**CITY OF SACRAMENTO**

Permit No: 0504430

Site Address: 7421 POCKET RD SAC

Nature of Work: REMODEL BATHROOM

New floor plan

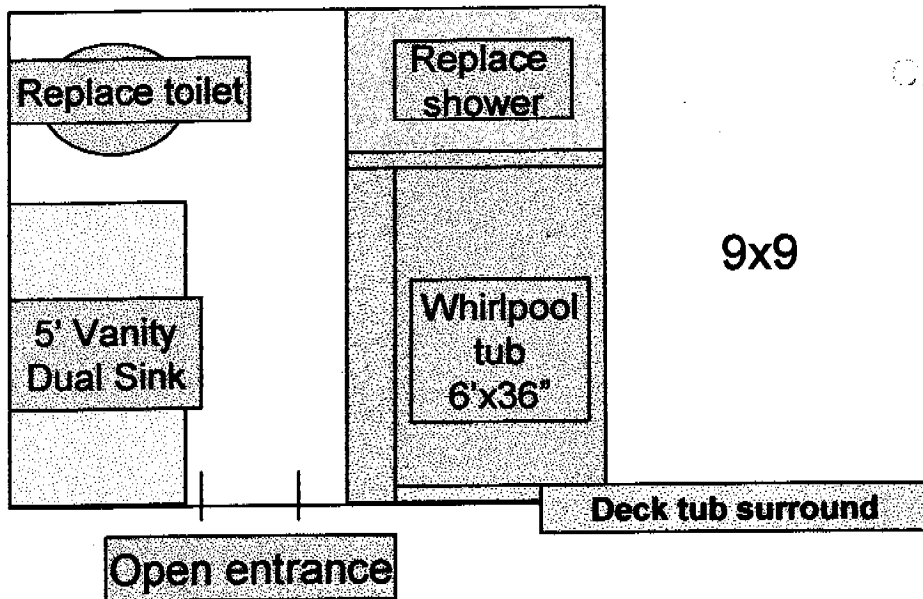
INSTALL ALL GFCI  
 PER NEC 210-8

THE APPROVAL OF ALL  
 PLUMBING / MECHANICAL /  
 ELECTRICAL  
 IS SUBJECT TO FILED INSPECTION

9x9 ALL DWELLING BRANCH  
 CIRCUITS PER NEC  
 ARTICLE 210
